# Planning & Zoning Board

# ZON24-00998 Highlights

- Rezone from RM-2 to RM-4 with a BIZ Overlay
- Site Plan Review for a 15-unit multiple residence development

Work Session June 10, 2025

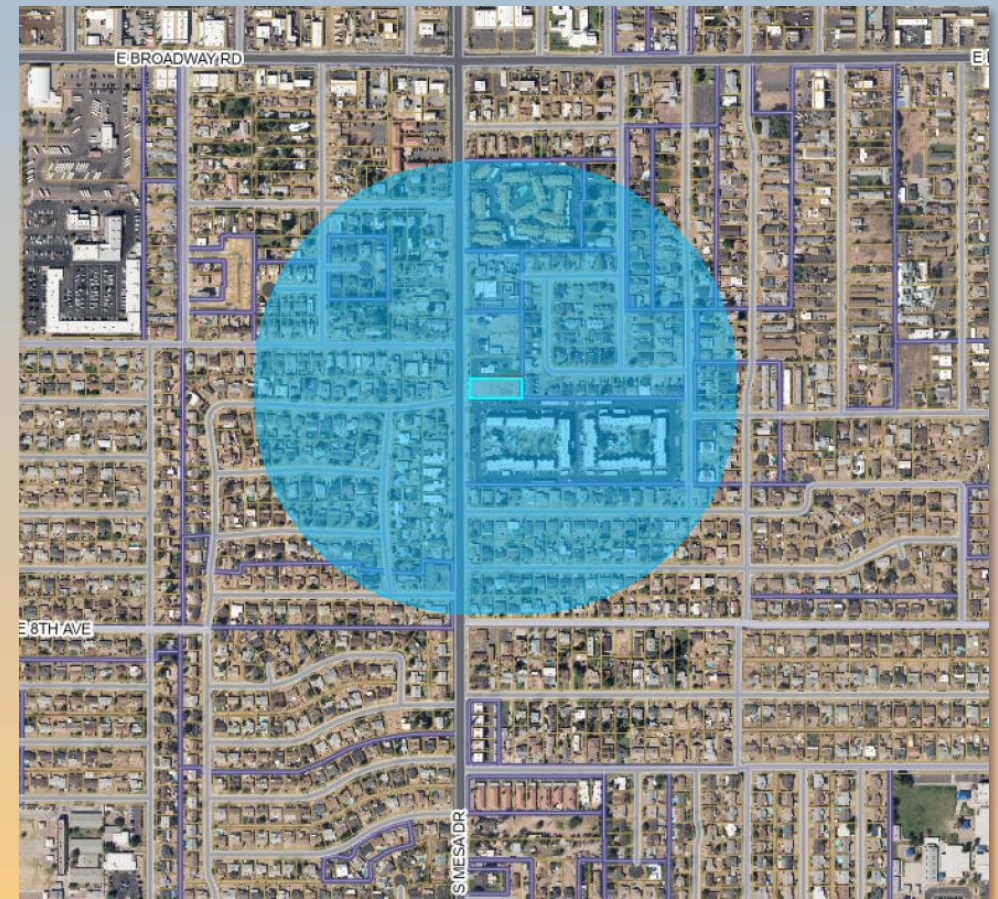
- Tiered garden concept is nice, provide larger area [Larger planters provided](#)
- Increase the area of the amenity space [Due to site constraints, we can't enlarge the space, but a bonus area was added North of bldg 1](#)

- Too tight between the buildings [Enlarging the drive aisle will reduce the amount of space where the pedestrian walkway is. To maintain a comfortable pedestrian experience, the drive aisle will remain as shown.](#)

- Cubelike; not enough movement [See revised elevations](#)
- Needs additional movement on the non-garage side [See revised elevations](#)
- Wall articulation – 2nd story bump out 12" instead of 6" [Doing so would encroach on drive aisle width](#)

- Vertical siding entries should be at the 25% for the entry elevation [See revised elevations](#)
- Long-term maintenance of colors?
- Remove colors from top hats [See revised elevations](#)

- Paint SES to match adjacent walls [See revised site wall plan.](#)

- Planters are tight [See revised amenity area](#)
- Swap the sidewalks at the perimeter for the planters so that there is more space for landscaping [Sidewalks at perimeter are needed to access unit entries.](#)
- Oaks drop sap (messy), also Oaks near the parking areas is problematic [See landscape](#)
- Taller trees needed [See landscape](#)
